**DOMUSEA DEVELOPMENTS
PROPOSED RESIDENTIAL DEVELOPMENT
THE BOWERIES, BARNHAM ROAD,
EASTERGATE**

STAGE 1 - ROAD SAFETY AUDIT

OCTOBER 2019

Project Code:	S/DDEastergate.1.6
Prepared by:	Martyn Parr
Approved by:	John Reid
Issue Date:	October 2019
Status:	Final

scale 1:250 @ A3 date OCTOBER 2019 drawing number MBSK191001-01	title VISIBILITY SPLAYS AT ACCESS	client DOMUSEA DEVELOPMENTS project THE BOWERIES, BARNHAM ROAD EASTERGATE	drawn by JME checked by AP cad file FIGURES A.DWG rev. D
---	-----------------------------------	---	---

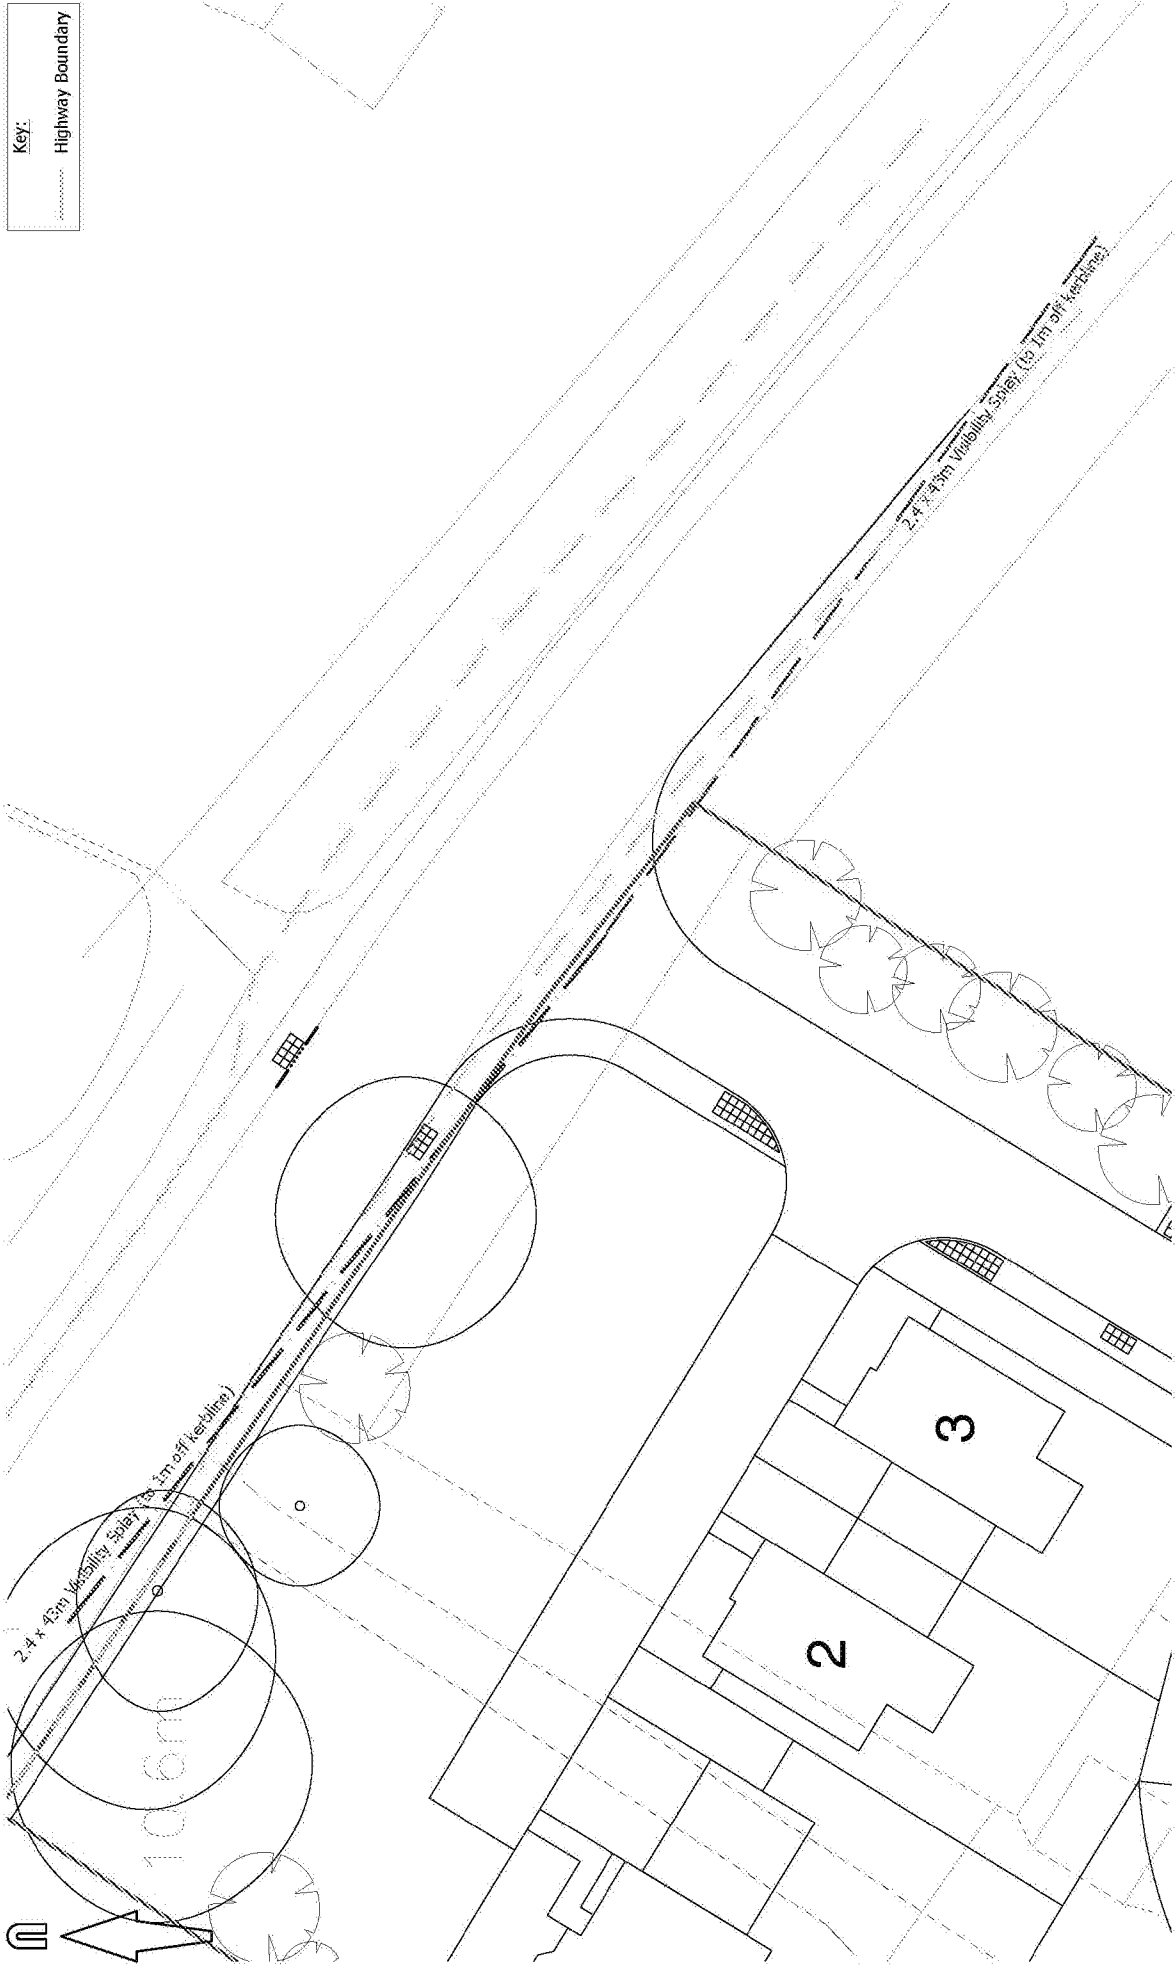
- 1.8 The Audit is concerned only with the Section 278 works that are to be adopted by the West Sussex County Council.
- 1.9 All comments and recommendations are referenced to a reduced scale copy of drawing 'MBSK191001-01D', provided in **Appendix B** of this report.
- 1.10 The proposals comprise of residential development with 18 dwellings. Access will be provided via the existing 'The Boweries' access.

2.5 Problem

Location: Site Access

Summary: Obstruction to visibility splays

Junction visibility splays have been formally identified on the drawings provided for Audit. It will be important that any vegetation within these splays is trimmed/maintained to ensure that the visibility splays remain unobstructed.

Recommendation

- i. Any vegetation within the splays should be trimmed/maintained.
- ii. Vegetation within the splays should not extend beyond a vertical height of 0.6m.
